Golden Crest, LLC
4532 42nd Avenue S.W.
Seattle, Washington

DESIGN RECOMMENDATION #3 - 07/23/09

Design Guidelines

Recommendation and Conditions

West Elevation

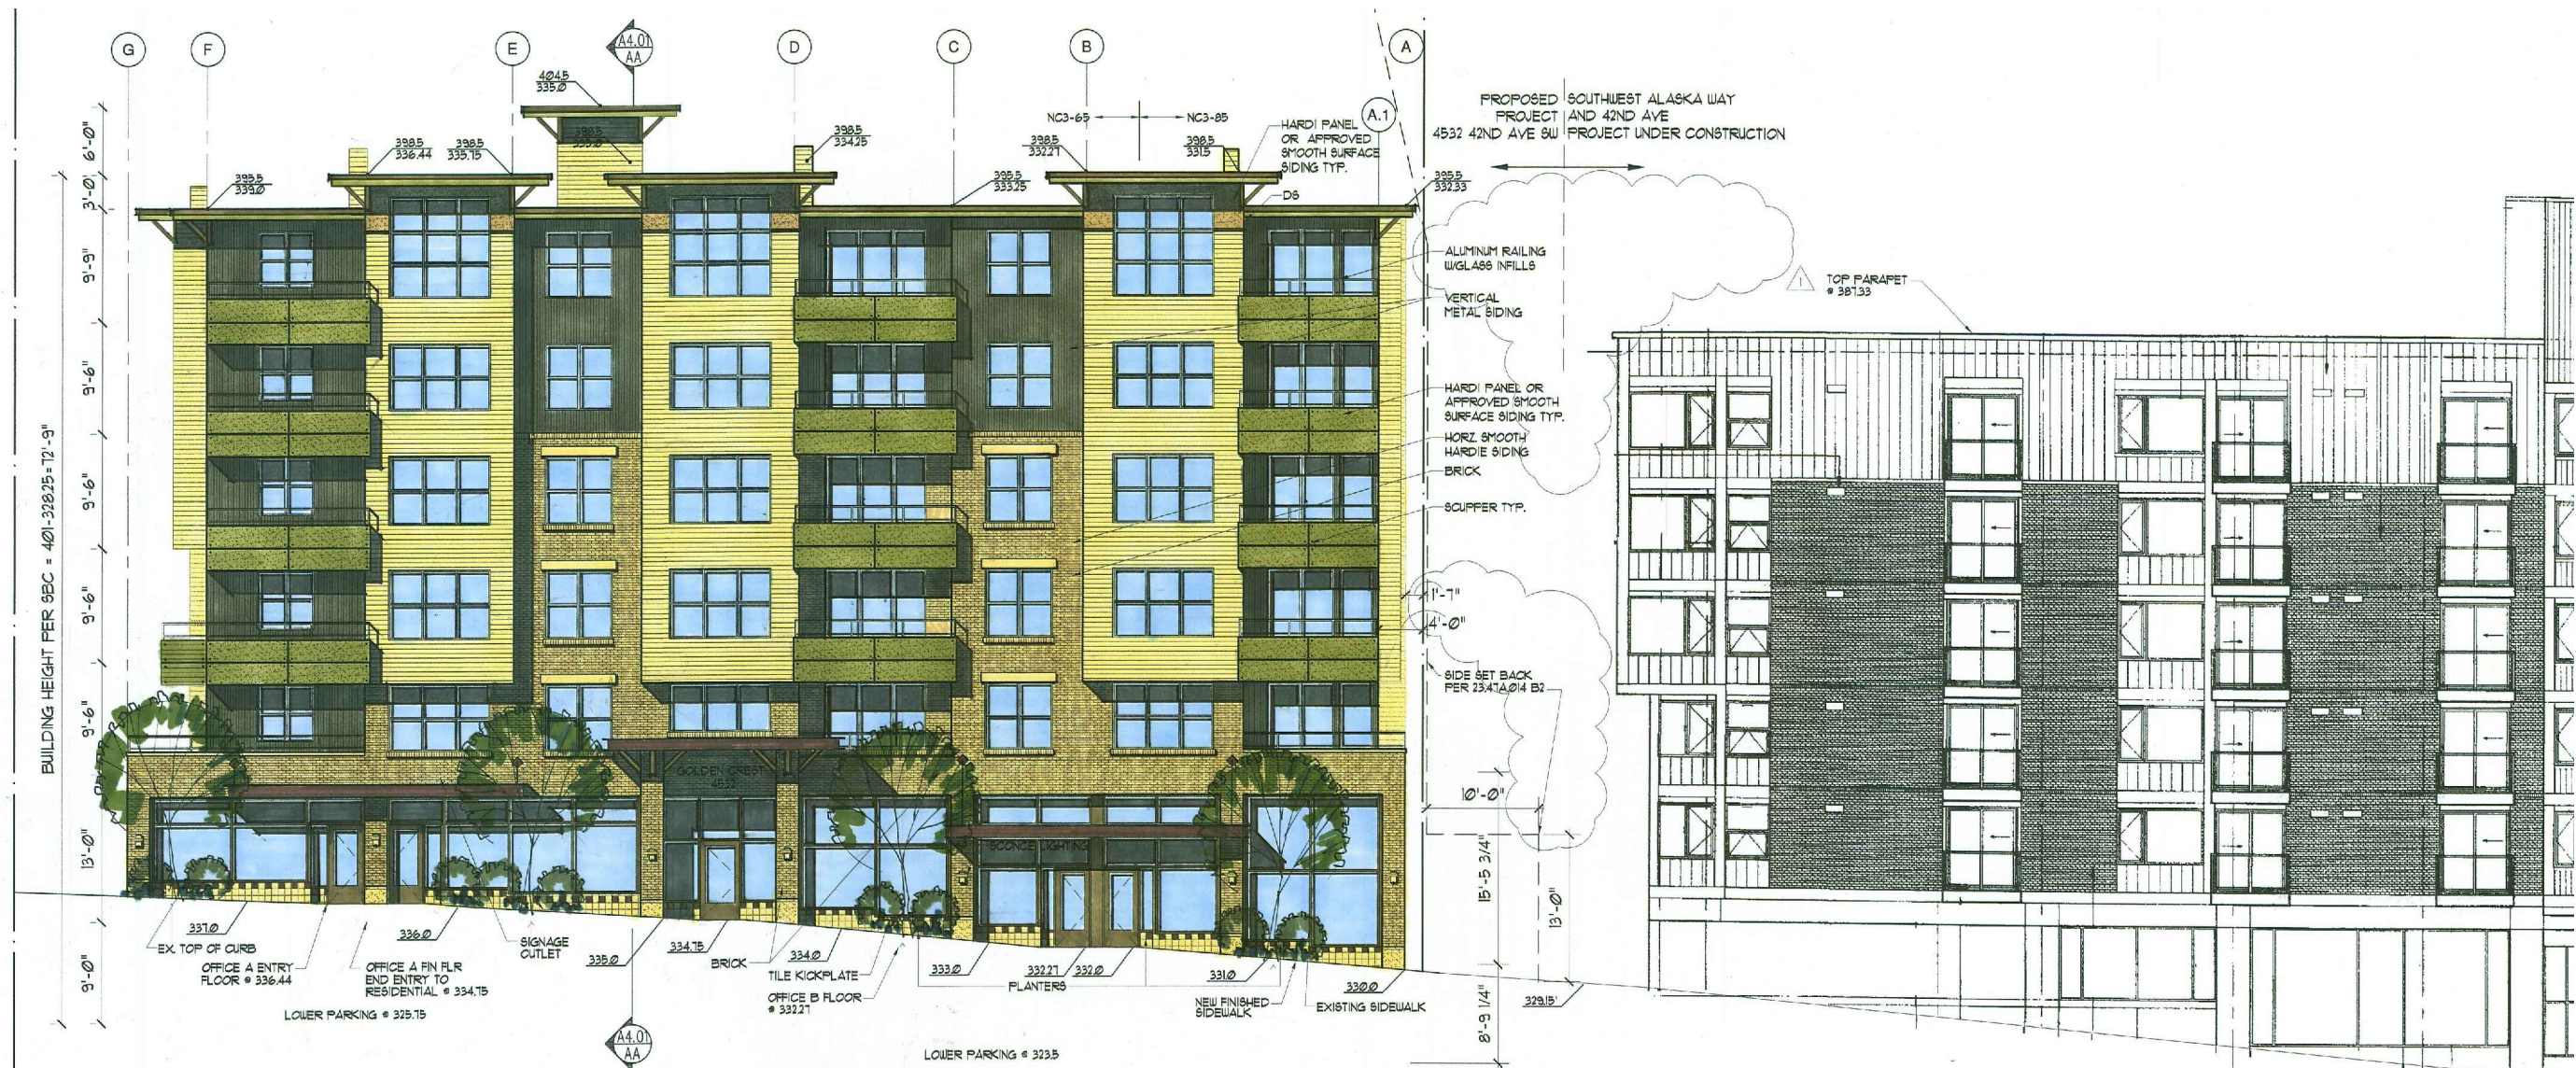
The applicant should modify the design to push the entire building mass as close to the west property line as possible. The street level retail spaces should be as close to the sidewalk as possible and not divided from the sidewalk by planters. The retail and building entry should include continuous overhead weather protection which may extend into the public right of way. The proposed garage entries and trash/services area at the alley should also be designed to minimize impacts to the townhouse residents to the east. The trash area should be reconfigured so the doors open to the south. The applicant should examine the potential for locating one of the garage entries at the south façade instead of both facing the townhouses to the east. The proposed metal siding was of some concern regarding noise impacts to adjacent residential development. The Board requested that the applicant provide information about acoustics and noise transmission of rain on metal siding.

The Board recommended that the design should be modified to provide better visual integration of the upper floors and the street level façade. The Board noted that a "hierarchy" of materials is needed, with use of materials to create a clear base, middle and top of the building, and to tie the three elements together. Possible solutions include additional use of color to emphasize massing changes, additional glazing at the street level, a cornice cap above the storefront level, lighting at the building columns and vertical elements, emphasis of the cast in place concrete base material with a stone or other durable material application, and an increase in the mass of the brackets at the upper floor soffits.

- Modify the design of the west façade to visually unite the upper and lower portions of the building and enhance the proposed massing with materials, colors, lighting, etc.
